Office Action Summary	Application No. 10/030,799	Applicant(s) DONDERS, STEVEN	
	Examiner Jori R. Schiffman	Art Unit 3679

DETAILED ACTION

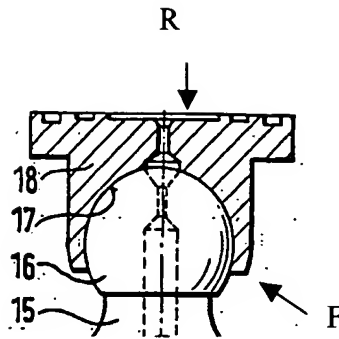
Regarding claims 20 and 23, Wagenseil discloses (Fig. 1) a ball-and-socket joint (16, 17) forming a connection between a piston 1 and a slipper 18 of a piston machine, the joint comprising a hemispherical joint recess 17 having a free recess edge, labeled as F on the Figure below, provided at one end of the piston, and a spherical joint ball 16 on the slipper being pivotably mounted in the joint recess 17. Wagenseil does not specifically disclose that the free recess edge is formed by hot-beading. However, applicant is reminded that “[E]ven though product-by-process claims are limited by and defined by the process, determination of patentability is based on the product itself. The patentability of a product does not depend on its method of production. If the product in the product-by-process claim is the same as or obvious from a product of the prior art, the claim is unpatentable even though the prior product was made by a different process.” *In re Thorpe*, 777 F.2d 695, 698, 227 USPQ 964, 966 (Fed. Cir. 1985). Therefore this limitation has not been given patentable weight.

Regarding claim 28, Wagenseil discloses the claimed joint including a base surface on the slipper with a recess, labeled as R on the Figure above, but fails to disclose the slipper including a base surface with a plate-shaped insert being mounted in the recess. Wiethoff teaches a plate shaped insert 132 mounted in the recess of the base member of the slipper. It would have been obvious at the time the invention was made to a person of ordinary skill in the art to include a plate shaped insert mounted in the recess of the base member of the slipper so the slipper can slide more easily.
